CSP-18001
DSP-18016

Application	General Data	
Project Name: Marlow Heights Center Location: In the southwest corner of the intersection of Riviera Street and 28th Avenue. Applicant/Address: PAAP Properties, LLC 462 Indian Greens Lane Manns Choice, PA 15550	Planning Board Hearing Date:	03/14/19
	Staff Report Date:	2/25/19
	Date Accepted:	12/14/18
	Planning Board Action Limit:	04/25/19
	Plan Acreage:	0.25
	Zone:	M-X-T
	Dwelling Units:	N/A
	Gross Floor Area:	10,176 sq. ft.
	Planning Area:	76A
	Council District:	07
	Election District:	06
	Municipality:	N/A
	200-Scale Base Map:	206SE04

SUBJECT: Conceptual Site Plan CSP-18001
Detailed Site Plan DSP-18016
Marlow Heights Center

SITE PLAN

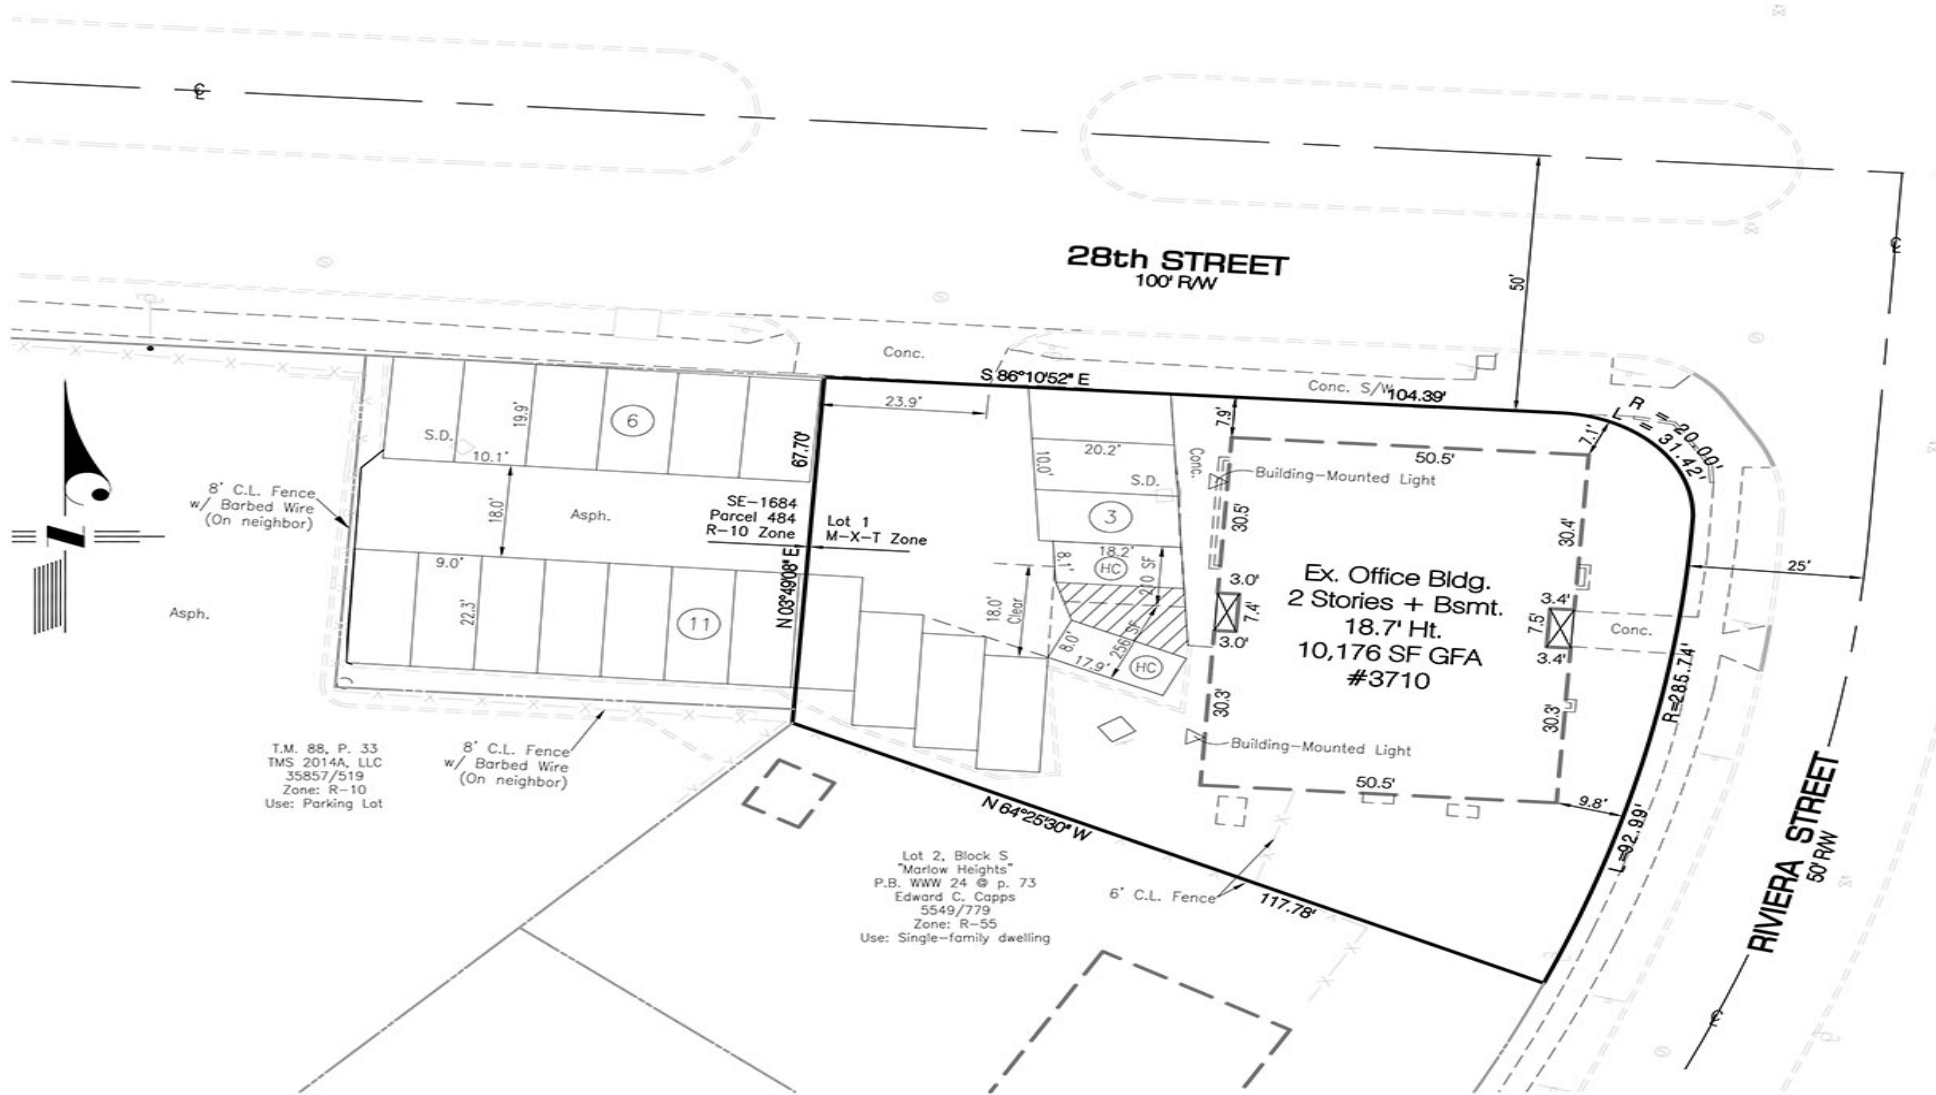
****The DSP shows 22 parking spaces; however, the parking schedule states that 21 spaces are proposed. A condition has been added to the Recommendation section of

Generally, the parking spaces and drive aisle meet those regulations, but differ in several locations. Therefore, a condition has been included in the Recommendation section of this report requiring the applicant to revise the dimension of the parking spaces and drive aisle width to either meet the minimum required in 1968 or the current requirements.

It is noted that the loading schedule shown on the plan is calculated incorrectly and has been calculated based on the uses in the building. The loading schedule should be revised, in accordance with Section 27-582, to show the required number of loading spaces for an office building or office building complex based on the square footage or GFA of the building, and is conditioned herein.

A trash facility appears to be shown on the west side of the building but is not clearly labeled on the plan. Per current aerial imagery, this is a trash dumpster; therefore, a condition has been included in the Recommendation section of this report requiring the applicant to screen or enclose the trash facility with an evergreen screen, or sight-tight fence, that is compatible with the building.

The plan shows an eight-foot-high, chain-link fence with barbwire along the west and south sides of the parking compound on the adjacent Parcel 33, with no fence on Parcel 484. Therefore, a condition has been added to the Recommendation section of this report requiring that the five-foot high, sight-tight fence be shown.

- f. Revise the parking schedule to indicate the total number of parking spaces proposed.
 - g. Correct the label of the special exception on adjacent Parcel 484 to SE-1654.

- h. Revise the number of loading spaces required, in accordance with Section 27-583 of the Prince George’s County Zoning Ordinance.
 - j. Reflect a five-foot-high, sight-tight fence abutting residential land adjacent to the side and/or rear lot line of Parcel 484, as required by Special Exception SE-1654.

- j. Revise the dimensions of the parking spaces and drive aisle to meet the minimum requirements in 1968, or meet the requirements of Sections 27-558 and 27-560 of the current Prince George's County Zoning Ordinance.
- k. Screen or enclose the trash facility with a sight-tight fence or evergreen screen.
